Re: Comments on ENERGY STAR Programs Version 6.0 Product Specification Framework Document

This letter is in response to the ENERGY STAR Programs with Windows, Doors, and Skylights Version 6.0 Product Specification Framework Document dated October 2011 ("Version 6.0 Document").

Figure 1: IRC Wind-Borne Debris Map

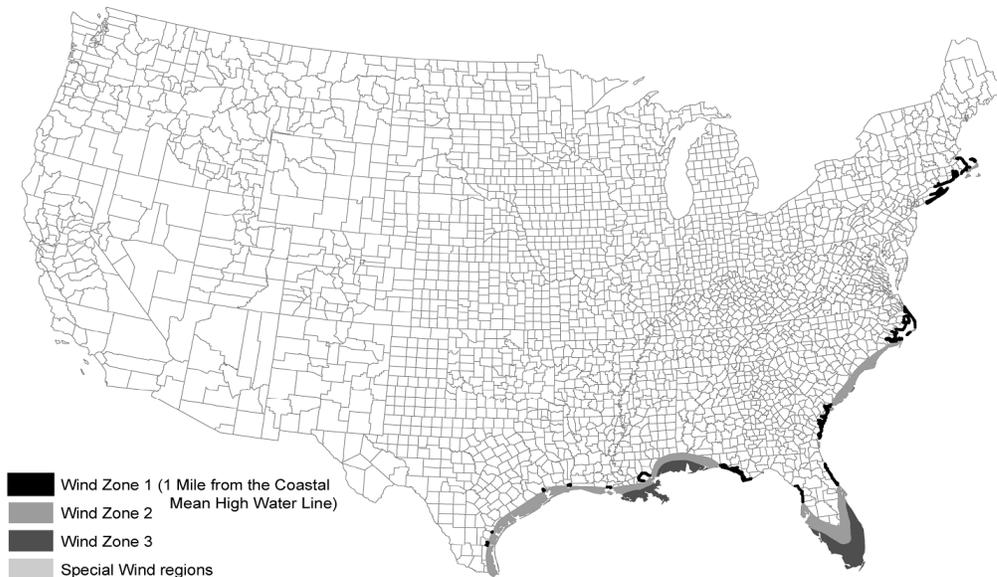
ENERGY STAR should definitely consider coastal areas of the United States that require wind-borne debris protection per the International Residential Code (“IRC”). JELD-WEN recommends a U-Factor allowance of 0.05 to accommodate the design challenges. The highlighted areas below require special glazings that need Energystar consideration by allowing the.05 adder.
